STAFF DESIGN COMMISSION REPORT RE-REVIEW

Project Name: Sigwalt Apartments
Project Address: 45 S. Chestnut Avenue
Prepared By: Steve Hautzinger

DC Number: 17-089
Petitioner Name: Michael Porto
Petitioner Address: CA Residential LLC
 130 E. Randolph Street, Suite 2100
 Chicago, IL 60601
Original Meeting Date: August 8, 2017
Re-Review Meeting Date: September 12, 2017

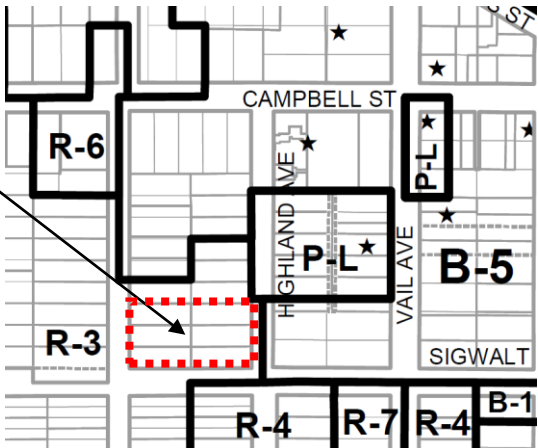
Overall, the proposed design has a nice composition that relates well to the buildings located directly adjacent in the Downtown, such as the Vail Avenue parking garage, Dunton Tower Apartments, and Metropolis Loft condominium. The design includes a nice mix and balance of exterior materials. The colors work well together and complement the adjacent Downtown buildings.
